SUBJECT: ISSUANCE OF AMENDMENT NO. 105 TO FACILITY OPERATING LICENSE NO.
DPR-35 - PILGRIM NUCLEAR POWER STATION (TAC #65491)

AMENDMENT TO FACILITY OPERATING LICENSE

Amendment No. 105
License No. DPR-35

RELATED TO LICENSE AMENDMENT FOR CYCLE 8 (RELOAD 7)

○ Core Flow < 90% rated ● Core Flow >= 90% rated

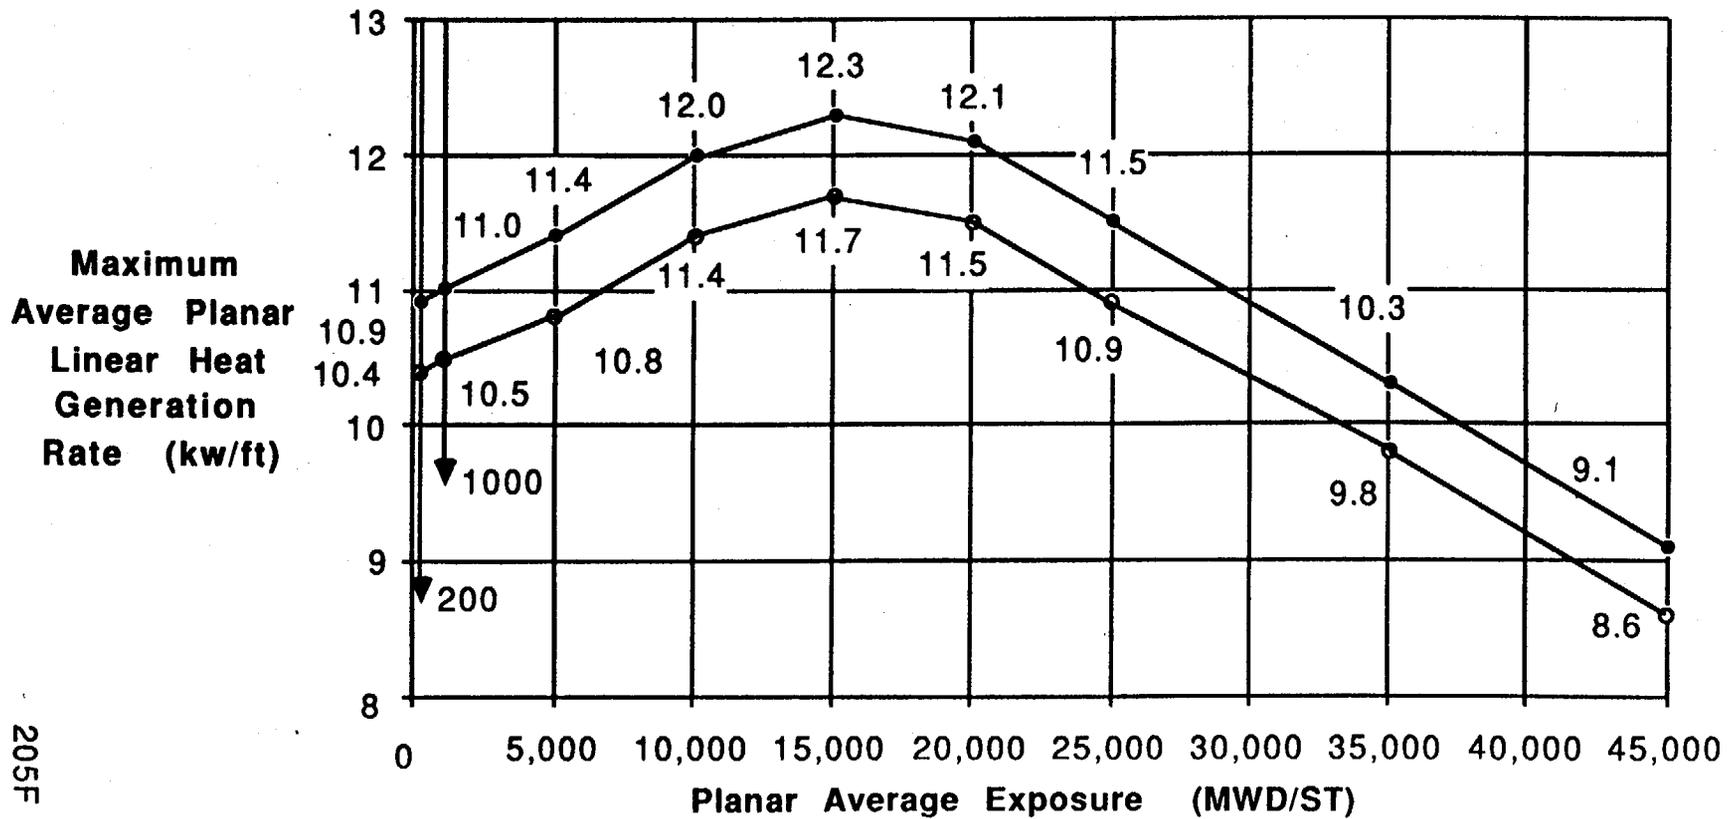
A new MAPLHGR curve is provided for the new fuel. A standard unit of fuel exposure, megawatt days per standard ton (MWD/ST), was established as uniform nomenclature. These changes are acceptable as discussed in Section 2.5.
